APPENDIX C INDEPENDENT REVIEW

Review of Car Parking Rates - 110-114 Herring Road, Macquarie Park

Figure 1 Private vehicle usage vs car ownership, Macquarie Park

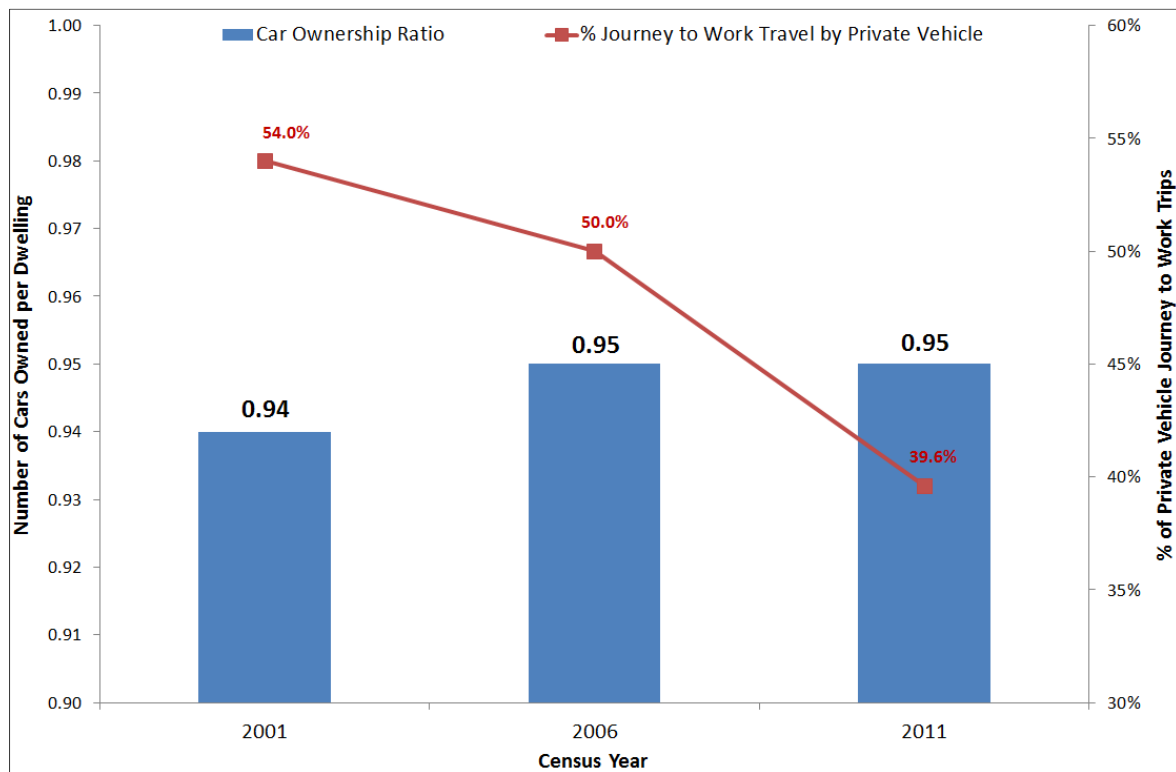
This is illustrated in Figure 1 below, indicating the proportion of private vehicle journey to work trips and car ownership of Macquarie Park residents. While car ownership has remained relatively static over the past decade, the level of car usage as a mode of travel to work has decreased significantly. The sudden drop between 2006 and 2011 can be attributed to the opening of the Chatswood to Epping railway line in 2009.
